Proposed Corriegarth 2 Wind Farm: Response to SEPA Consultation Request

Appendix A – Amended Figures

Corriegarth 2 Wind Farm

Ordnance Survey data © Crown copyright and database right 2021. OS 100030994, Airbus, USGS, NGA, NASA, CGIAR, NCEAS, NLS, OS, NMA, Geodatastyreisen GSA, GSI and the GIS User Community

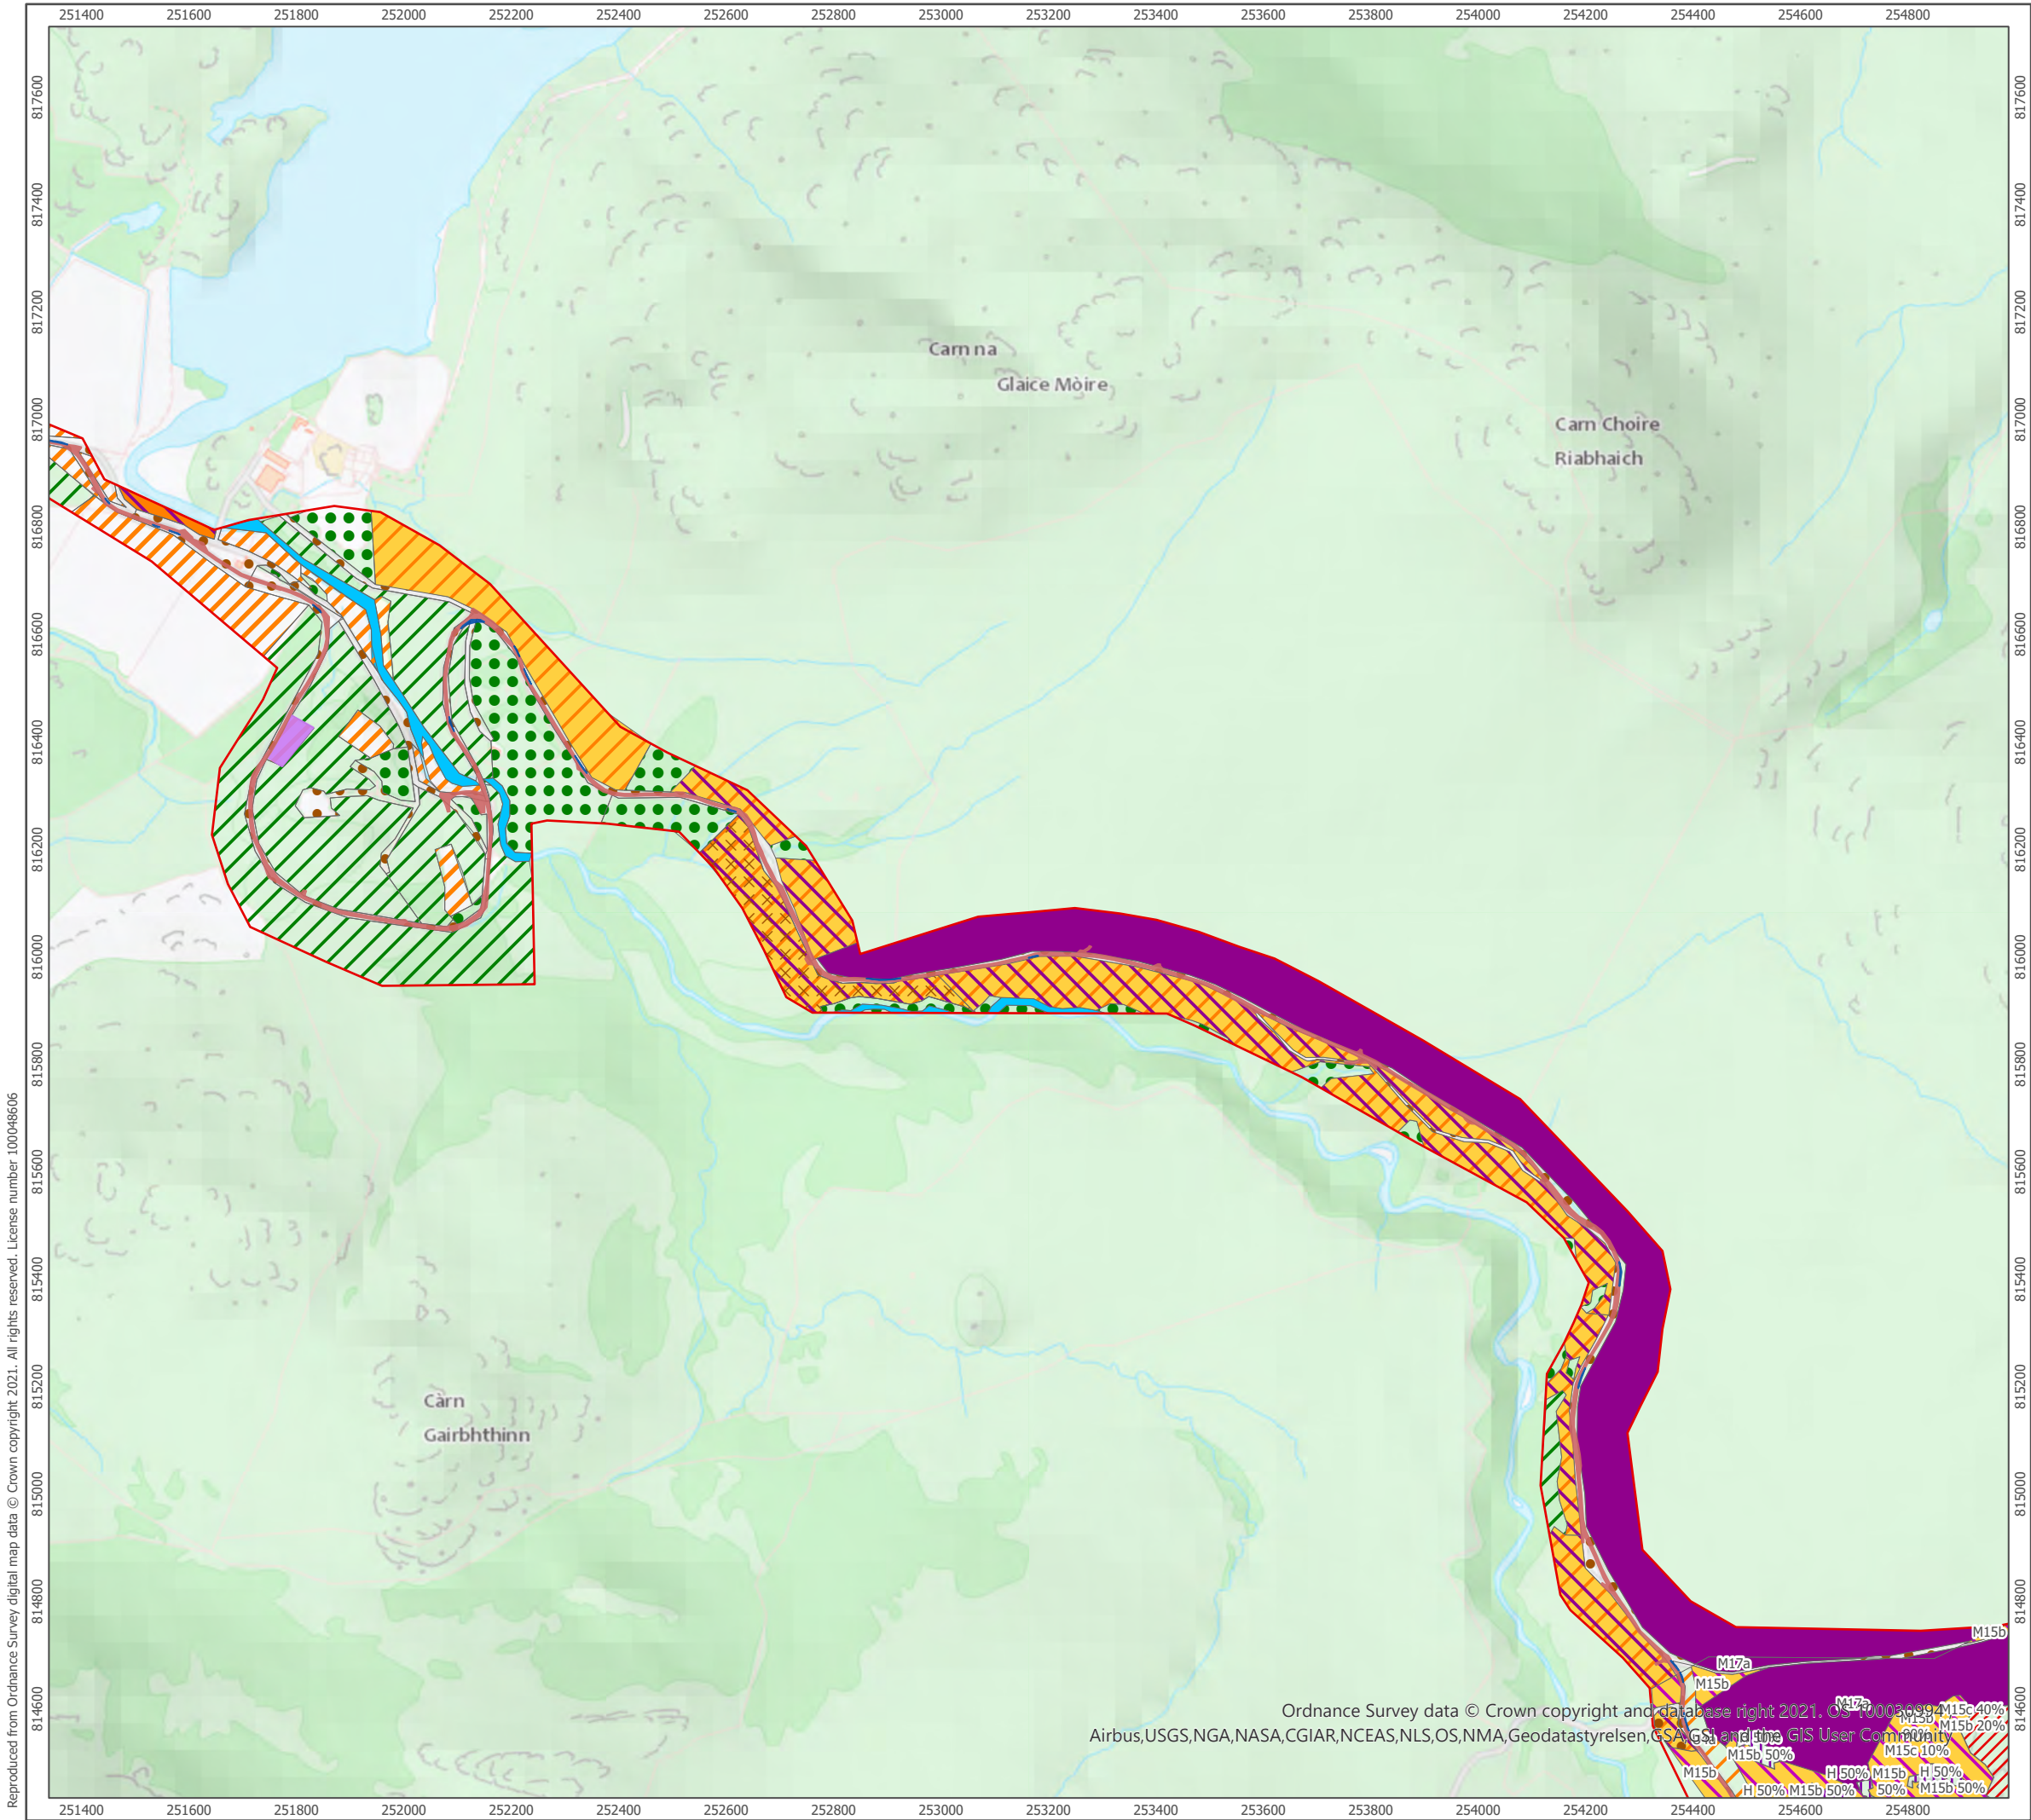
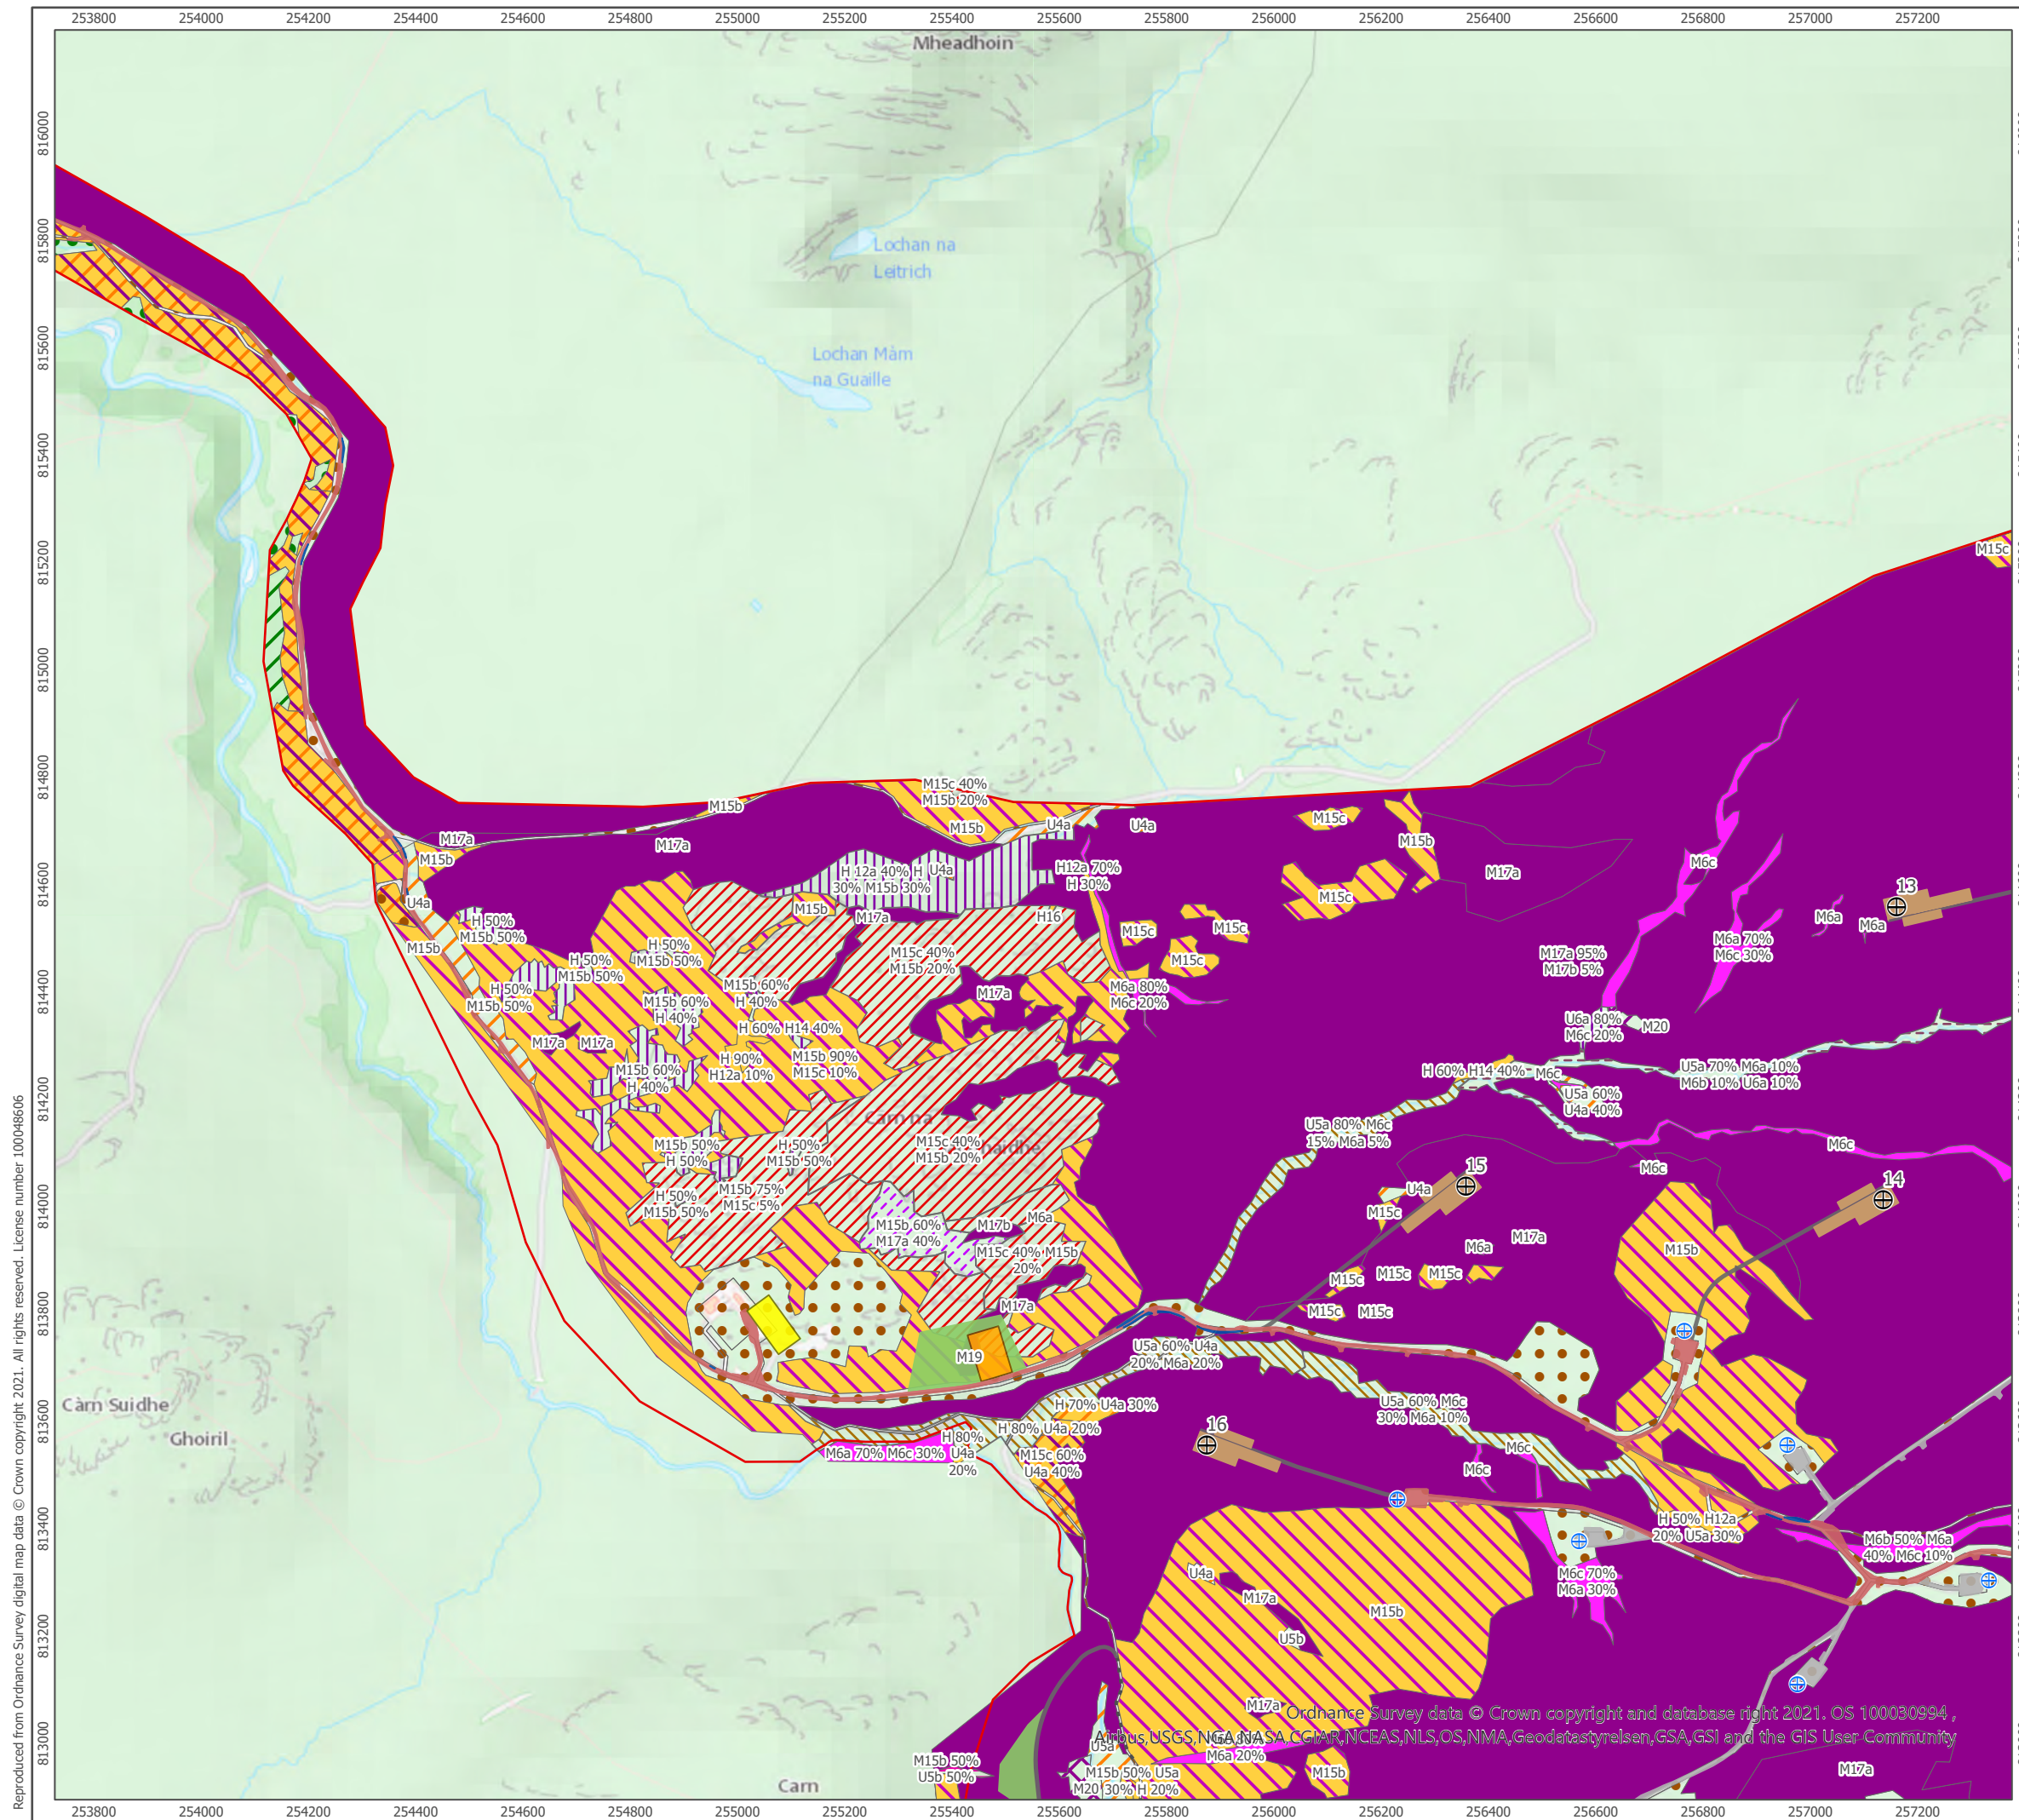
1. Figure 7.2 of Chapter 7: Ecology of the EIA Report is amended to include all proposed infrastructure associated with the Development (clearly marked);
2. All of the figures contained within Technical Appendix A7.1: Habitats and Botany Surveys to include all proposed infrastructure associated with the Development (clearly marked); and
3. Figure 13.2.2 of Technical Appendix A13.2: Outline Peat Management Plan to be provided on OS Basemapping; to be provided in a map series format; and with a revised symbology colour ramp.

SEPA Amendment Request¹	Applicant Response
1.	Arcus Consultancy Services Ltd ('Arcus'), on behalf of Corriegarth 2 Wind Farm Limited ('the Applicant'), have added all proposed new infrastructure associated with the Development to Figure 7.2. The added infrastructure associated with the Development is clearly marked via the legend. Due to the number of entries in the legend, the text and indicative symbol boxes have had to be reduced; however, it is considered that all information remains clear. Figure 7.2 also includes the NVC labels, as requested by SEPA through further discussion with Arcus (via telephone 06/07/2021). Figure 7.2 now also includes an overview figure for ease.
